Access Compliance Report

Public Rights-of-Way

(Curb Ramps)

Intersection ID: 3583	Main Street: ARDEN_GATE_LN	Cross Street: TREYMORE_LN	Location: W
ADA ID: 09CCA33C4B3D	Ramp Type: Perp	Initial Pass/Fail: Fail	Overall Compliance: No
Severity Score: 1.25			
Codes/Mitigation Info/Possible Solution		Field Measurements/Component Compliance

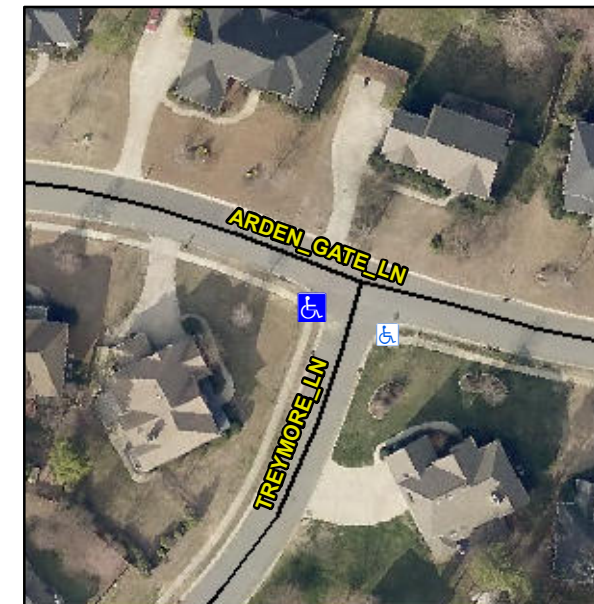
Not Found, R304.5.3

Compliance	Description	Data	Compliance	Description	Data
N/A	Ramp Length (in)	47.0	Yes	Ramp Slope (%)	6.5
Yes	Ramp Width (in)	63.0	No	Ramp XSlope (%)	5.0
N/A	Flare Type LT	N/A	N/A	Flare Type RT	N/A
N/A	Flare Slope LT (%)	N/A	N/A	Flare Slope RT (%)	N/A
N/A	Flare Traversable LT?	N/A	N/A	Flare Traversable RT?	N/A
N/A	Landing Length (in)	N/A	N/A	DWS Provided?	N/A
N/A	Landing Width (in)	N/A	N/A	DWS Contrast?	N/A
N/A	Landing Slope (%)	N/A	N/A	DWS Length (in)	N/A
N/A	Landing X Slope (%)	N/A	N/A	DWS Full Width?	N/A
N/A	Landing Curb? (Y/N)	N/A	N/A	DWS Offset (in)	N/A
N/A	Shared Landing?	N/A			
N/A	Gutter Ponding?	N/A	N/A	Gutter Slope (%)	N/A
N/A	Gutter Lip Ht (in)	N/A	N/A	Gutter X Slope (%)	N/A
N/A	Painted X Walk1?	No	N/A	Painted X Walk2?	N/A
	X Walk 1 Direction	To SE		X Walk 2 Direction	N/A
N/A	X Walk 1 Width (in)	N/A	N/A	X Walk 2 Width (in)	N/A
	X Walk 1 Slope (%)	0.7		X Walk 2 Slope (%)	N/A
	X Walk 1 X Slope (%)	1.2		X Walk 2 X Slope (%)	N/A

Remove & Replace Entire Ramp.
